Item ID: D206-667-201TRN

Item Name: Crosstube Turning Detail

DART AEROSPACE LTD		Work Order:	140410
Description: Crosstube Assembly		Part Number:	D206-667-241
Inspection Dwg: D206-667-241 Rev: C		Page 1 of 2

DRAWING NO. D206-667-241	TITLE CROSSTUBE ASS'Y (206B HIGH AFT)	REV. C	DART AEROSPACE LTD ENGINEERING ORDER		D.E.O. NO. D206-667-241-C-1	SHEET NO. SHEET 1 OF 1	SCALE NTS
DRAWN <i>92</i>	CHECKED <i>AS</i>	MFG. APPR. <i>M</i>	APPROVED <i>WD</i>		DE APPR. <i>HA</i>		
DATE 11.07.15	DATE 11.08.22	DATE 11.08.22	DATE 11/08/22		DATE 11.08.22

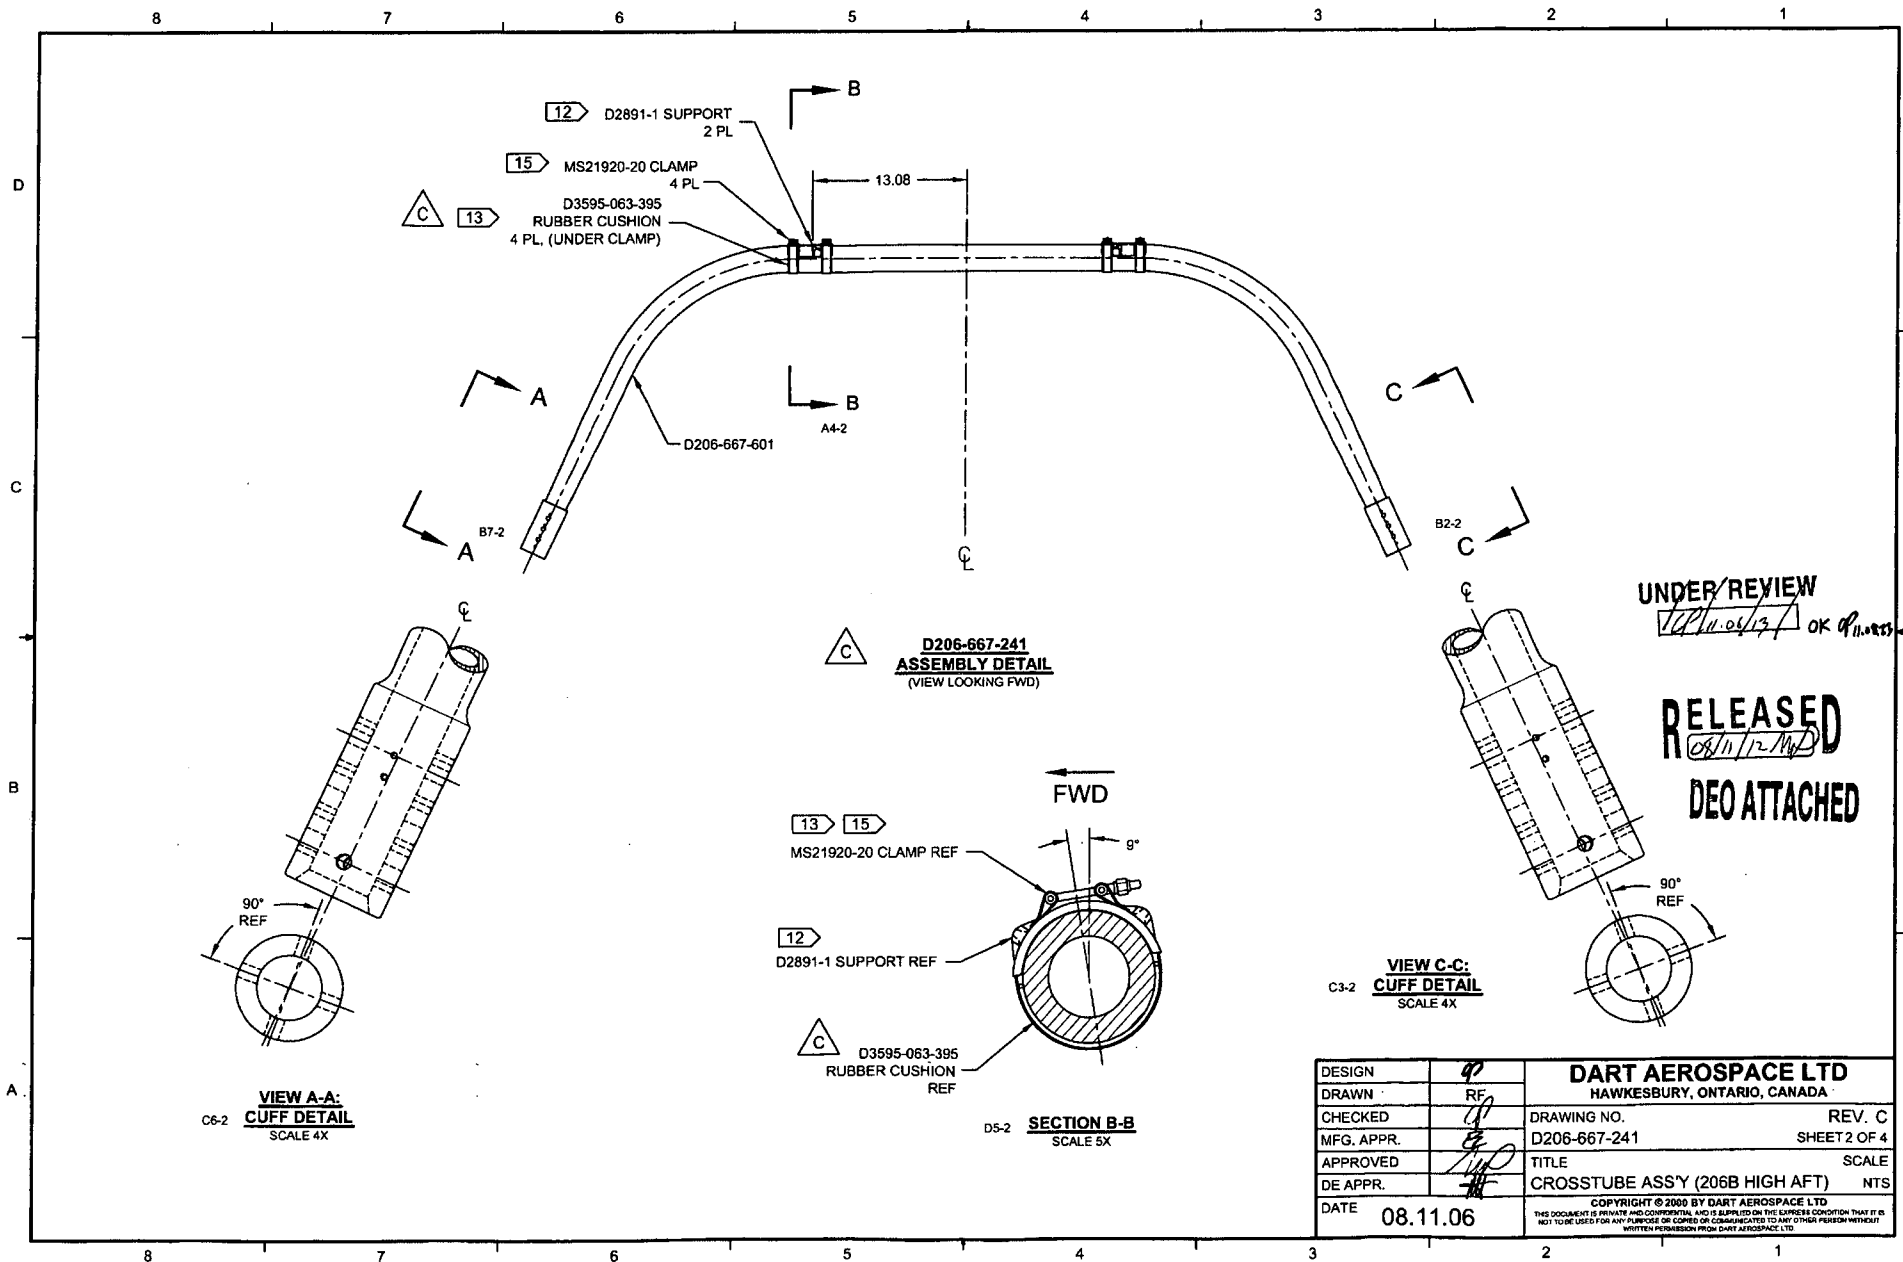
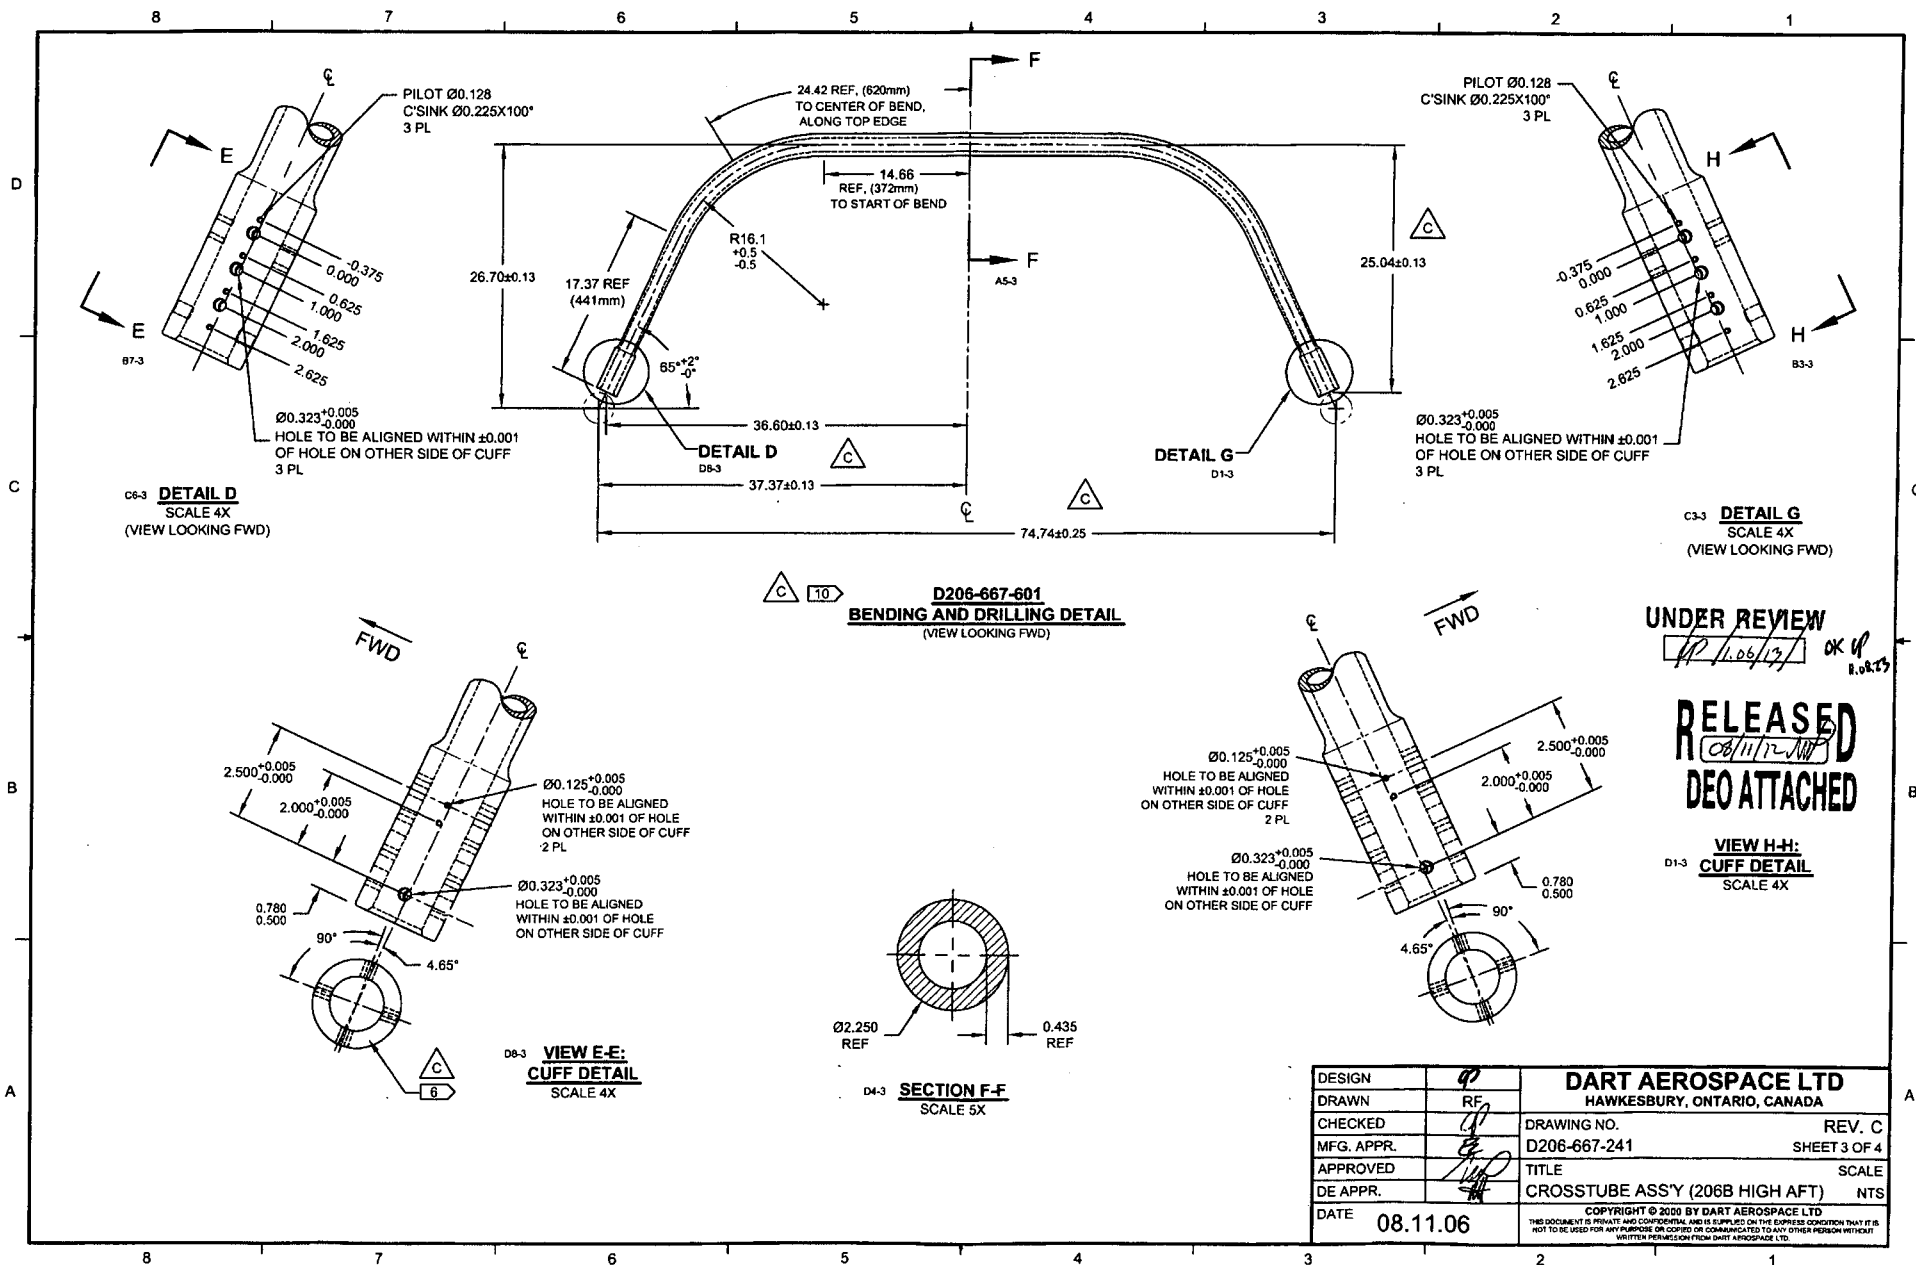
PURPOSE:

REPLACE MAGNOBOND WITH PROSEAL.

IS:

Item	Qty -241	Part Number	Description
6	A/R	PROSEAL 890 B-2	SEALANT, AMS-S-8802 CLASS B-2

WAS:

6	A/R	MAGNOBOND 6398	ROCKWELL SPECIFICATION RBO-120-023 ADHESIVE (TEXTRON/BELL SPEC. 299-947-100, TYPE II, CLASS 2 ADHESIVE)
---	-----	----------------	---

NOTE 12 & 15, SHEET 1 IS AMENDED AS FOLLOWS:

IS:

- 12) TO INSTALL D2891-1 SUPPORT: ABRASE MATING SURFACE OF SUPPORT AND CROSSTUBE WITH 180-GRIT SANDPAPER AND REMOVE RESIDUE WITH MEK (OR EQUIVALENT). APPLY A 0.04" TO 0.07" THICK LAYER OF PROSEAL 890 CLASS B-2 (OR AMS-S-8802 CLASS B-2) SEALANT TO MATING SURFACE OF SUPPORT.
- 15) TORQUE CLAMPS 80 TO 100 IN-LB. ENSURE AT LEAST 1.5 THREADS SHOWING IN SAFETY AND THAT NUT HAS NOT BOTTOMED-OUT AFTER TORQUING. **PRIOR TO PACKAGING, RE-CHECK TORQUE ON CLAMPS AFTER PROSEAL 890 SEALANT HAS CURED FOR 72 HOURS.**

WAS:

- 12) INSTALL D2891-1 SUPPORT USING 0.03" TO 0.06" THICK LAYER OF MAGNOBOND 6398 PER QSI 015. LET CURE FOR 12 HOURS AFTER INSTALLATION AND PRIOR TO PACKAGING.
- 15) TORQUE CLAMPS 80 TO 100 IN-LB. ENSURE AT LEAST 1.5 THREADS SHOWING IN SAFETY AND THAT NUT HAS NOT BOTTOMED-OUT AFTER TORQUING.
